Proposed Equivalent Safety Finding to CS 23.1305, 23.1311, 23.1321 and 23.1549: Powerplant instruments

Statement of issue

Secondary EIS indication on the MFD or PFD

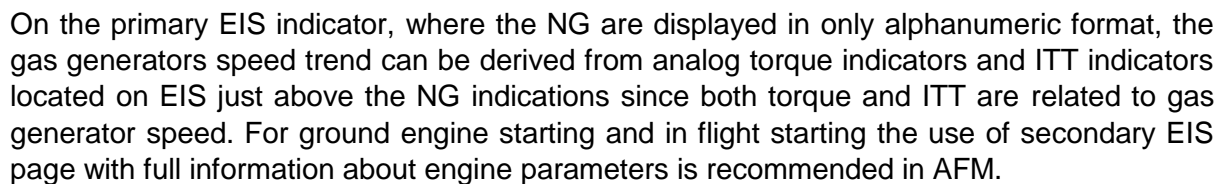
On secondary page of EIS, which can be displayed on either MFD or PFD, the NG together with all other engine parameters are displayed in the way of conventional gage with scale and pointer accompanied with alphanumeric presentation.

There is a color change of alphanumeric indication when gas generator approaches to its limiting values. There is a caution range in which the alphanumeric indication is provided by yellow color and over-speed range in which the alphanumeric indication is done by red color. Furthermore in case of the gas generator speed limit overrun the CAS notification is displayed on the MFD similarly as in case of other engine parameters exceeding.
